Attn: New River Community and Technical College
Lighting Replacement

The following items are part of the addendum for the above listed project. Receipt of this Addendum shall be sent to zstevens@sbmce.com.

PROJECT: Request for Bids (RFB) 21199
New River Community and Technical College
Lighting Replacement
Ghent, West Virginia

(OPTION #1)
HIGH BAY LIGHTING FIXTURE MOUNTING DETAIL
N.T.S.

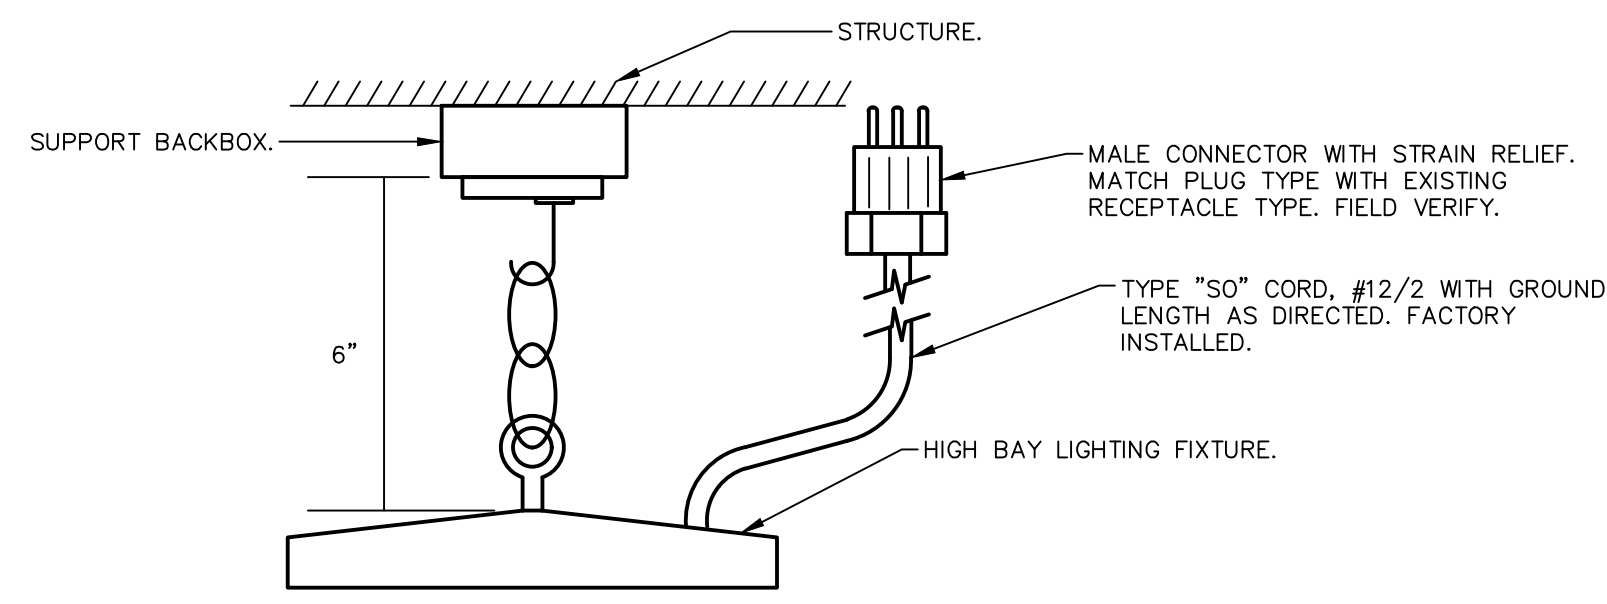
- a. Response: Yes.
4. Question: What is the mounting height of the new P1 fixtures?
 - a. Response: Refer to sheet E0.1 High Bay Lighting Fixture Mounting Details. The ceiling height ranges from 35' to 40'.
